SUBJECT: ISSUANCE OF AMENDMENT NO. 81 TO FACILITY OPERATING LICENSE
NO. NPF-8 REGARDING PRESSURE-TEMPERATURE LIMITS RELATING TO
GENERIC LETTER 88-11 - JOSEPH M. FARLEY NUCLEAR PLANT, UNIT 2,
(TAC NO. 77542)

AMENDMENT NO. 81 TO FACILITY OPERATING LICENSE NO. NPF-8 - FARLEY, UNIT 2

SAFETY EVALUATION BY THE OFFICE OF NUCLEAR REACTOR REGULATION
SUPPORTING AMENDMENT NO. 81 TO FACILITY OPERATING LICENSE NO. NPF-8
ALABAMA POWER COMPANY
JOSEPH M. FARLEY NUCLEAR PLANT, UNIT 2
DOCKET NO. 50-364

Figure 3.4-2 Farley Unit 2 Reactor Coolant System Heatup Limitations Applicable for the First 14 EFPY.

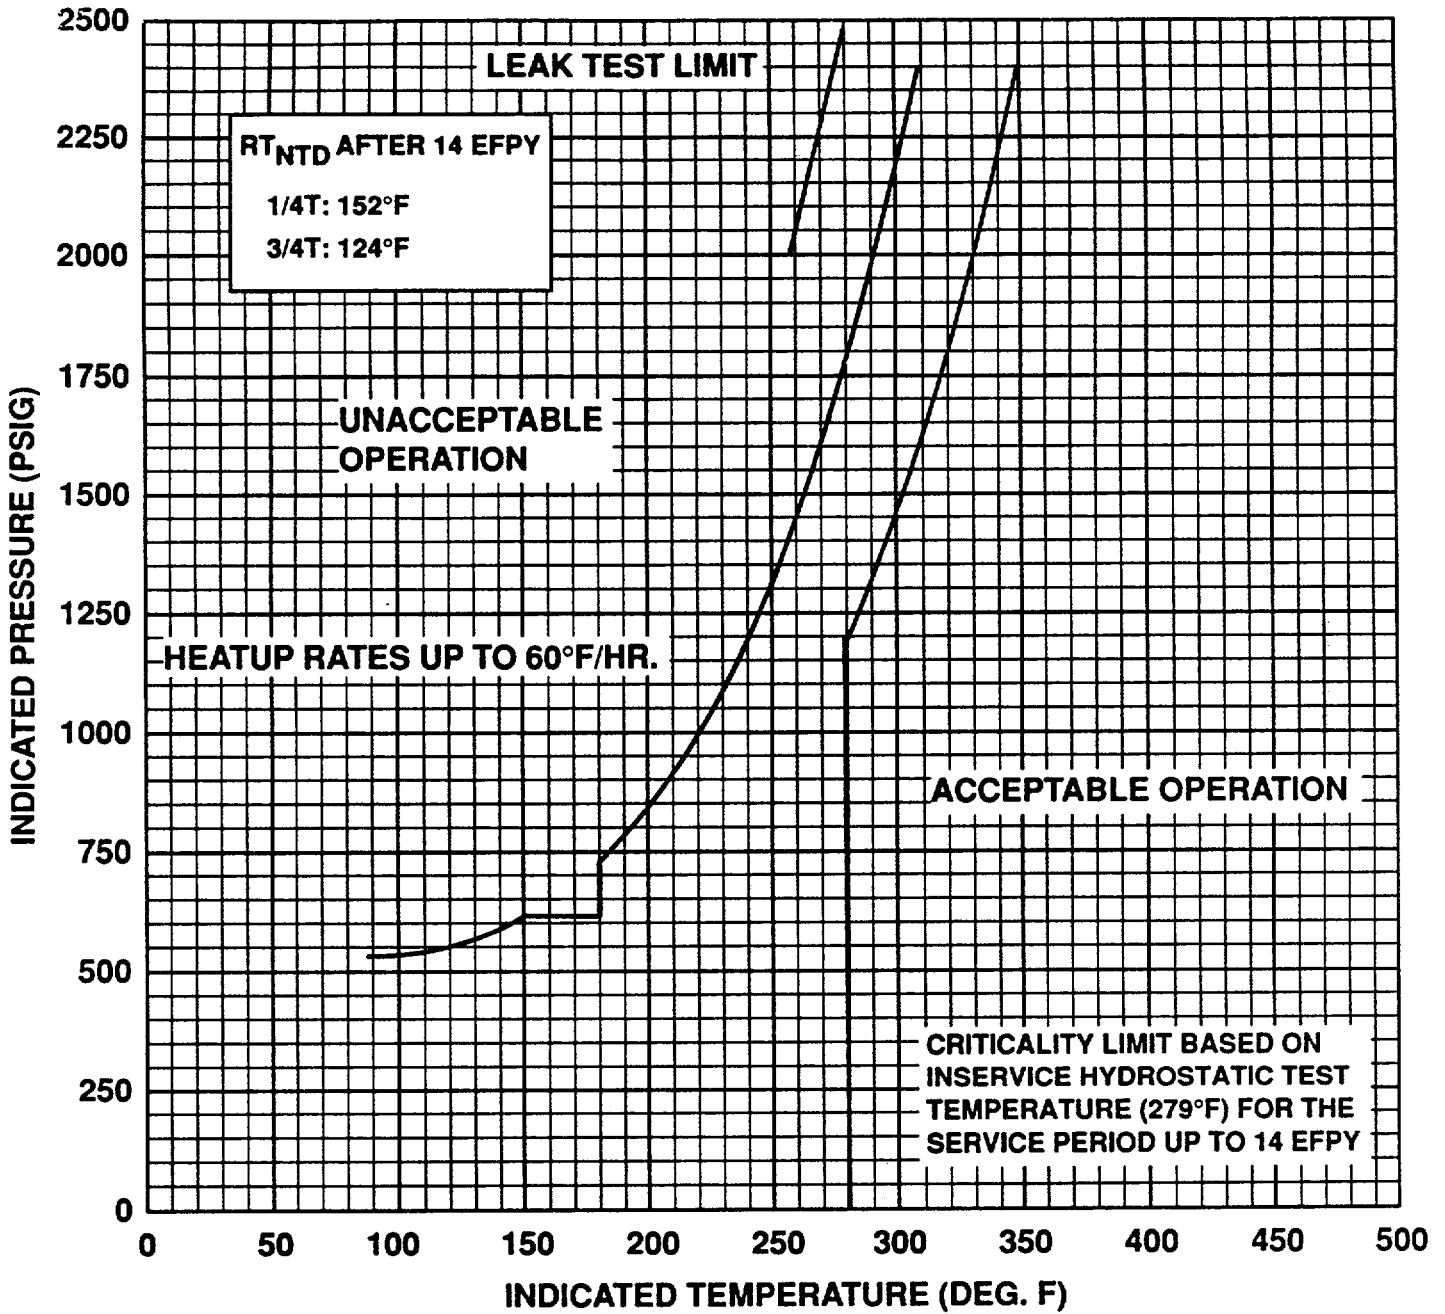
The amendment changes the Technical Specifications to provide heatup and
cool down curves applicable to the first 14 effective full power years
for the reactor.

The reactor vessel materials have been tested to determine their initial RT_{ndt} ; the results of these tests are shown in Table B 3/4.4-1. Reactor operation and resultant fast neutron (E greater than 1 MEV) irradiation can cause an increase in the RT_{ndt} . Therefore, an adjusted reference temperature, based upon the fluence and the nickel and copper content of the material in question, can be predicted using WCAP-12471 and the recommendations of Regulatory Guide 1.99, Revision 2, "Radiation Embrittlement of Reactor Vessel Materials." The heatup and cooldown limit curves of Figures 3.4-2 and 3.4-3 include predicted adjustments for this shift in RT_{ndt} at the end of 14 EFPY.

Finally, the 10CFR Part 50, Appendix G Rule which addresses the metal temperature of the closure head flange and vessel flange must be considered. This Rule states that the minimum metal temperature of the closure flange regions be at least 120°F higher than the limiting RT_{ndt} for these regions when the pressure exceeds 20 percent of the preservice hydrostatic test pressure (621 psig for Farley Unit 2). In addition, the new 10CFR Part 50 Rule states that a plant specific fracture evaluation may be performed to justify less limiting requirements. Based upon such a fracture analysis for Farley Unit 2, the 14 EFPY heatup and cooldown curves are impacted by the new 10CFR Part 50 Rule as shown on Figures 3.4-2 and 3.4-3.

The licensee calculated an ART of 152°F and 124°F at 1/4T and 3/4T, respectively, for the limiting material. The licensee's ARTs are more conservative than the staff's ARTs; therefore, they are acceptable. Substituting the ART of 149.5°F into equations in SRP 5.3.2, the staff verified that the proposed P/T limits for heatup, cooldown, and hydrotest meet the beltline material requirements of Appendix G to 10 CFR Part 50.
